DEVELOPMENT ASSESSMENT REPORT

Application No.	DA/2023/0251
Address	41 Salisbury Road STANMORE
Proposal	Alterations and additions to an existing semi-detached dwelling
Date of Lodgement	12 April 2023
Applicant	SKL Planning Pty Ltd
Owner	Mr Marcello Totaro
Number of Submissions	11 submissions of objection
Value of works	\$364,120.00
Reason for determination at Planning Panel	Number of submissions
Main Issues	<ul style="list-style-type: none"> • Heritage Conservation • View loss • Solar Access and Overshadowing • Matters raised in submissions
Recommendation	Approved with Conditions
Attachment A	Recommended conditions of consent
Attachment B	Plans of proposed development
Attachment C	Shadow Diagrams

Figure 2 - Image of No. 39 Salisbury Road's first floor rear facing balcony and associated glazing (Source: Google Street View).

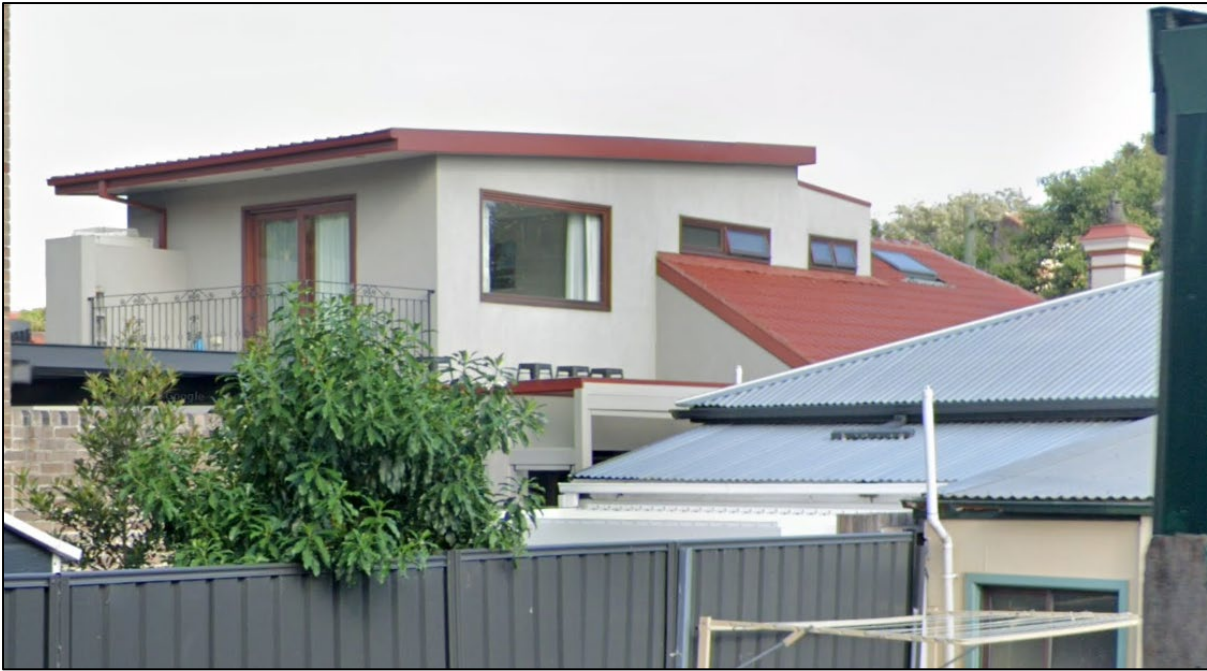
- The proposal also seeks to add two openings on the first floor of the south-western elevation (W2 and W3). Although the openings are positioned along the side elevation of the dwelling and face No. 39 Salisbury Road, the windows service the stairwell and the bathroom which are non-habitable areas and thus, there will be reduced levels of people traffic within these areas of the dwelling, resulting in minimised overlooking impacts. Further, the amended architectural plans indicate that the windows in question will consist of obscure glazing to mitigate any visual privacy impacts and satisfy C3(v)(a) of this Part of the MDCP 2011; and

- The proposed opening on the first floor of the south-eastern elevation (W1) accommodates two (2) 2.1m high windows and associated sliding door to service the Juliet balcony. The opening in question services a bedroom and will be solely utilised for light and ventilation purposes and is located at the rear of the dwelling; thus, satisfying C3(iii) of this Part of the MDCP 2011.

- The Juliet balcony will not allow for the space to be used as an extension to the existing private open space, meaning that its location off a bedroom would reduce opportunities for overlooking into neighbouring private open space and acoustic privacy impacts. The proposed Juliet balcony is of reduced size and scale in comparison to the directly adjoining property – No. 39 Salisbury Road (refer to Figure 2) and therefore, will have reduced impacts compared to existing development within the immediate vicinity of the site.

- W1 and the associated Juliet balcony will have minimal visual and acoustic privacy impacts on adjoining properties and thus satisfies the relevant controls and objectives contained under Part 2.18 of the MDCP 2011.
